Office Action Summary

Application No.	10/569,549	
Examiner	DREXLER ET AL.	
Edwin A. León	Art Unit 2833

DETAILED ACTION

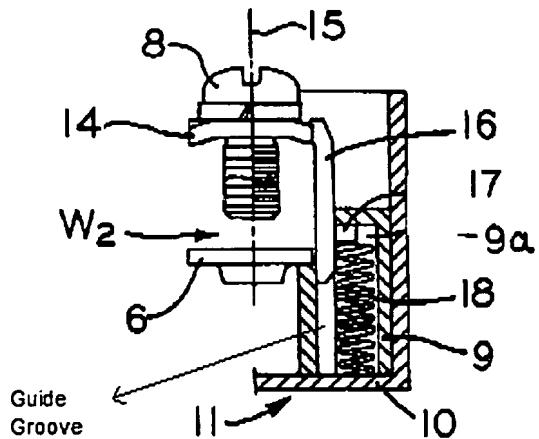
3. Claims 1-8 are rejected under 35 U.S.C. 102(b) as being anticipated by Isobe et al. (U.S. Patent No. 6,193,566). With respect to claim 1, Isobe discloses (in Fig. 11A) a switching device for the connection of a conductor by means via a ring terminal, comprising: a preassembled component (8, 14, 16) including a holder (16) and a screw-with-washer assembly (8, 14), the screw-with-washer assembly being held by the holder and forming, together with a connection piece (6), a clamping point (W2) for the conductor connection via the ring terminal, the holder being linearly movable between an open and a closed state of the clamping point and including a spring element (18)

applied to the holder, which holds the holder in the open state when the clamping point is released.

With respect to claim 2, Isobe discloses (in Fig. 11A) the component being not provided with a cover.

With respect to claims 3 and 5, Isobe discloses (in Fig. 11A) the component being guided and held via guide grooves (see following figure) during assembly.

With respect to claims 4 and 6-7, Isobe discloses (in Fig. 11A) the complete clamping device being in the form of a module, the switching device being plugged on (to operating section 1), and the spring element being prestressed over a narrow point (17) in the switching device.

With respect to claim 8, Isobe discloses (in Fig. 11A) a switching device for the connection of a conductor via a ring terminal, comprising: a housing (9, 10) supporting a connection piece (6); and a holder (16) supporting a screw-with-washer assembly (8, 14); wherein the holder is mounted on the housing for linear movement between an

open state in which the screw-with-washer assembly is spaced apart from the connection piece, and a closed state in which the screw-with-washer assembly is screw coupled to the connection piece.
